**WASTEWATER STUDY  
ROLLIN RIDGE ESTATES  
HODGEN ROAD AND HIGHWAY 83 – SOUTHWEST CORNER  
EL PASO COUNTY, COLORADO**

November 12, 2019

SEPTIC SUITABILITY MAP COMMERCIAL LOTS  
 ROLLIN RIDGE ESTATES  
 HODGEN ROAD AND HIGHWAY 83  
 EL PASO COUNTY, CO.  
 FOR: CARL TURSE

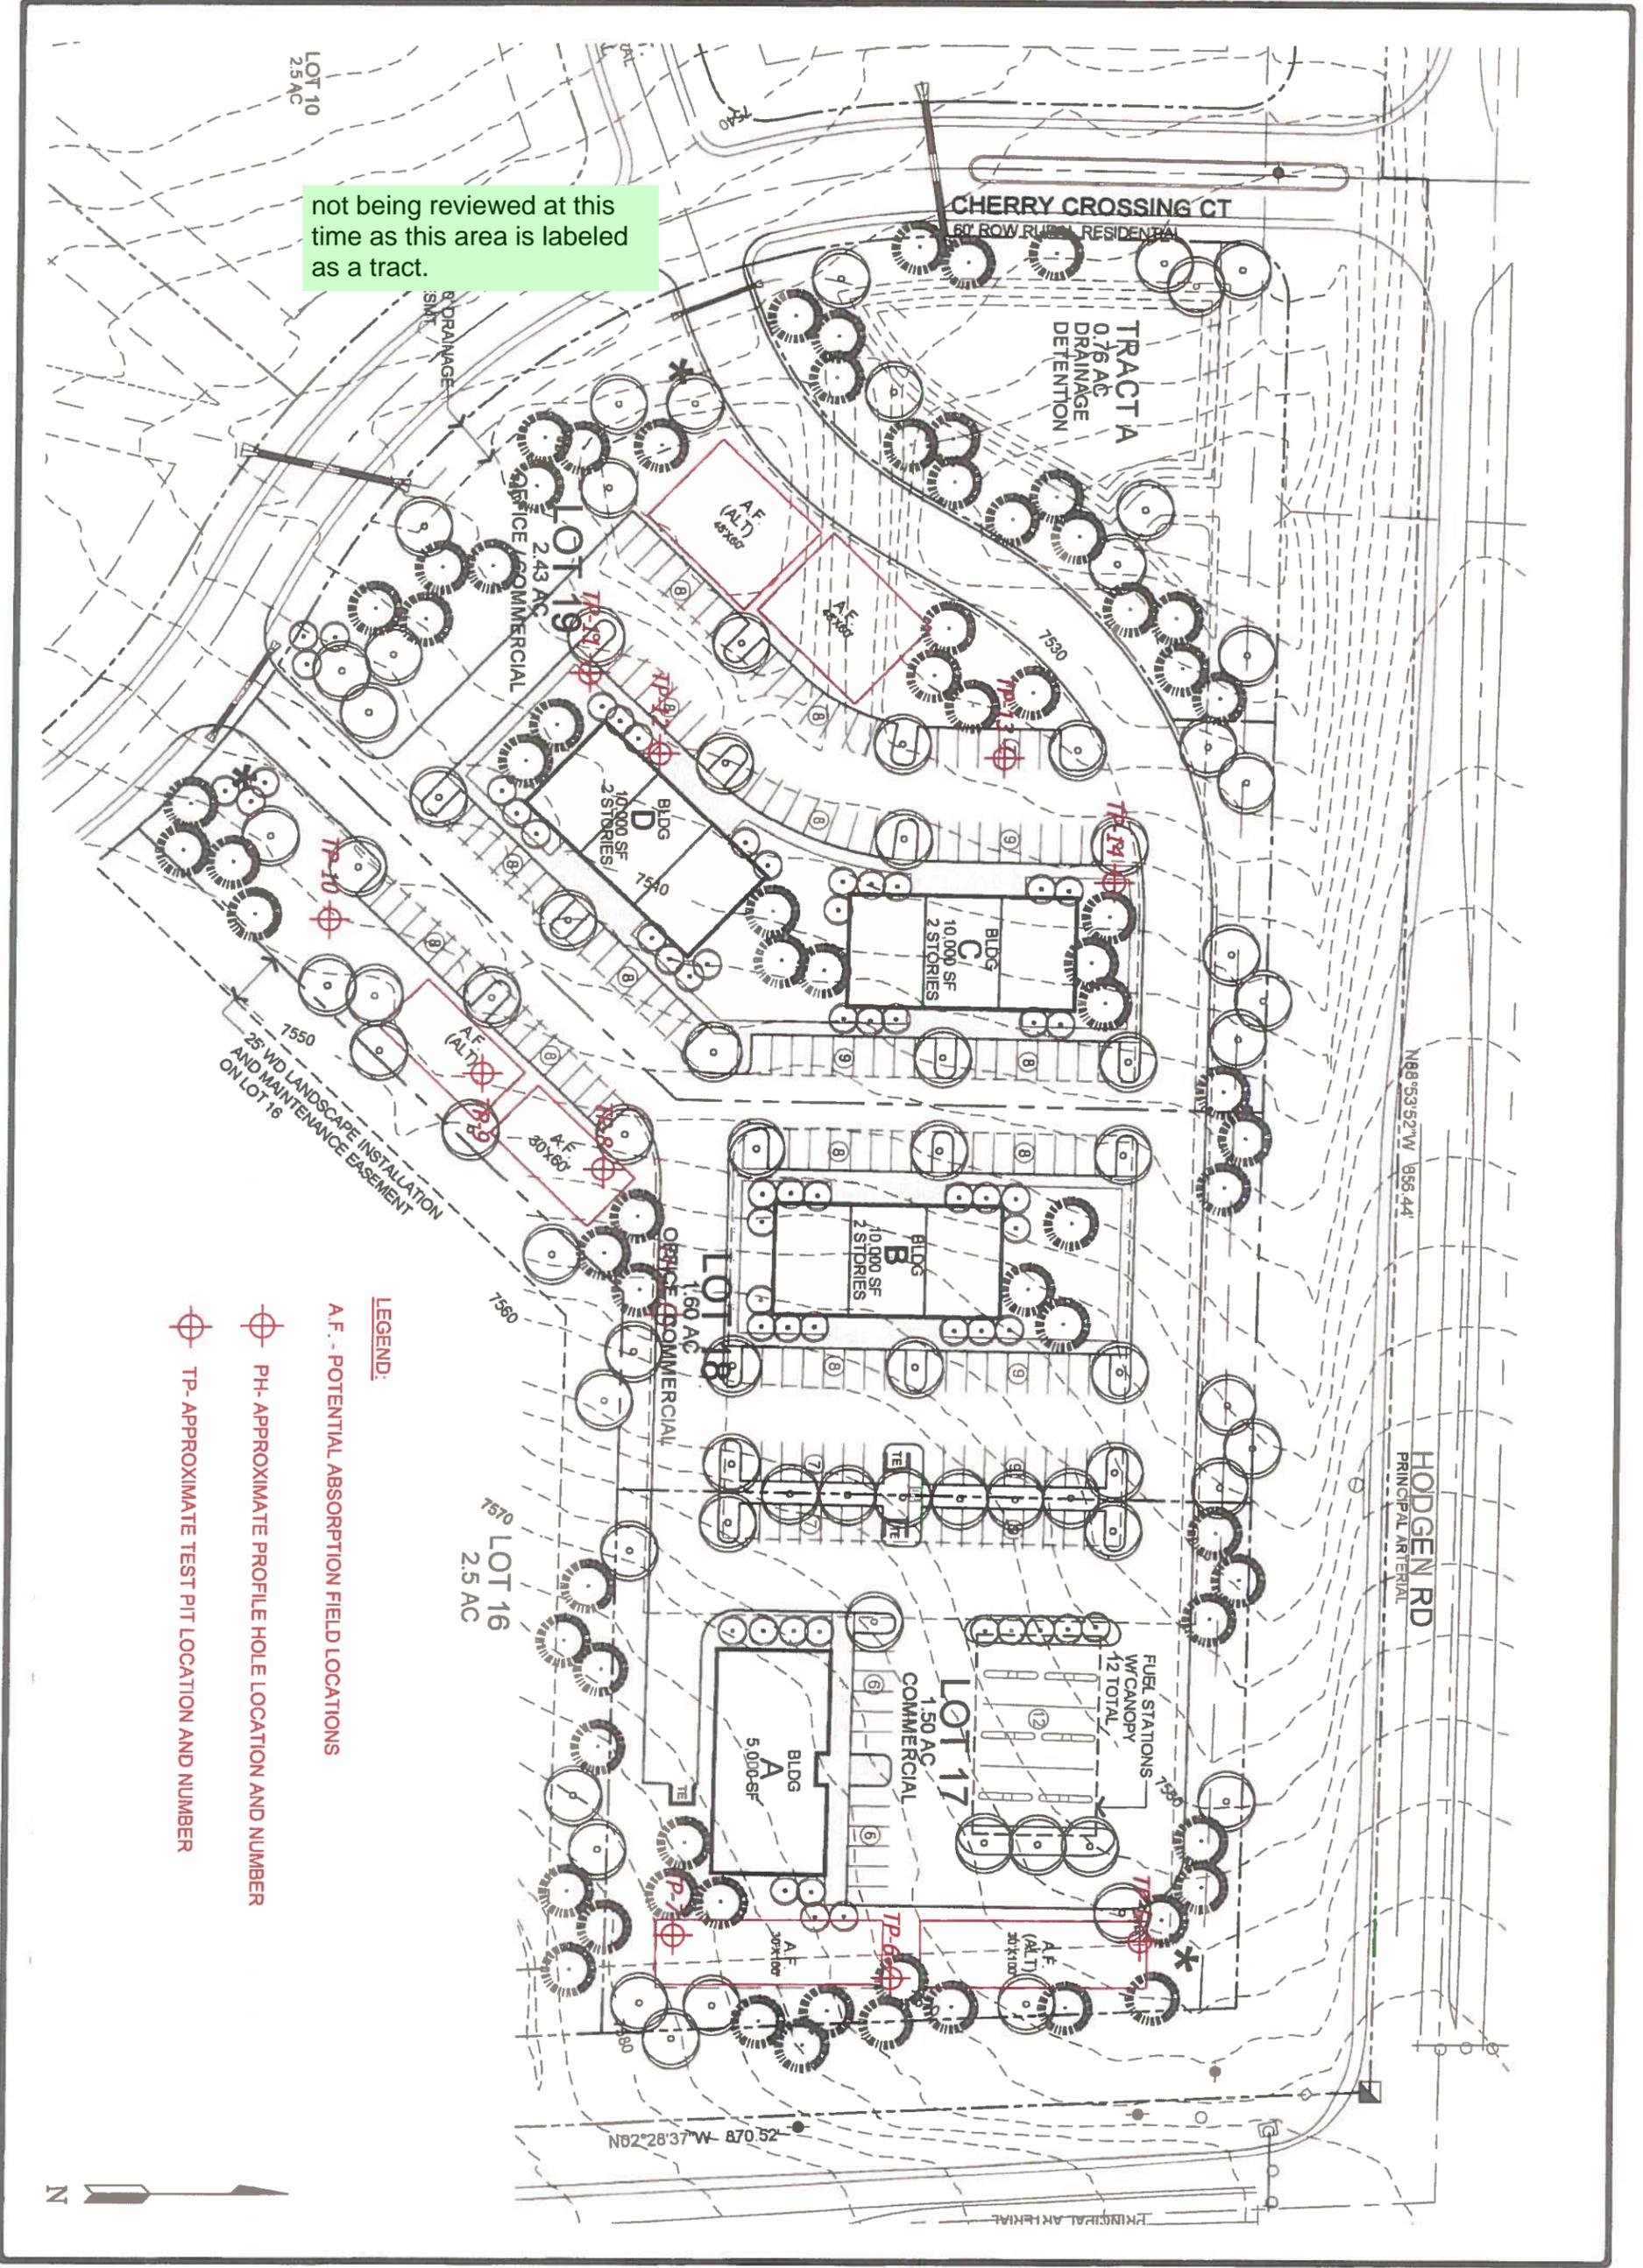
not being reviewed at this time as this area is labeled as a tract.
